Access Compliance Report

Public Rights-of-Way

Intersection ID: 46144	Main Street: EASTFIELD_VILLAGE_LN	Cross Street: ROCKY_FORD_CLUB_RD	Location: S
ADA ID: 3CF91BFD35FF	Ramp Type: Perp	Initial Pass/Fail: Pass	Overall Compliance: No
Severity Score: 0.25			
Codes/Mitigation Info/Possible Solution		Field Measurements/Component Compliance

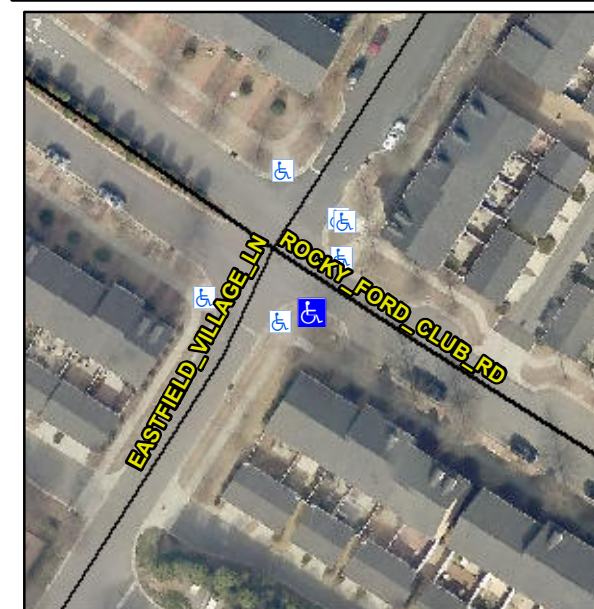
Remove & Replace Landing.

R304.2.1
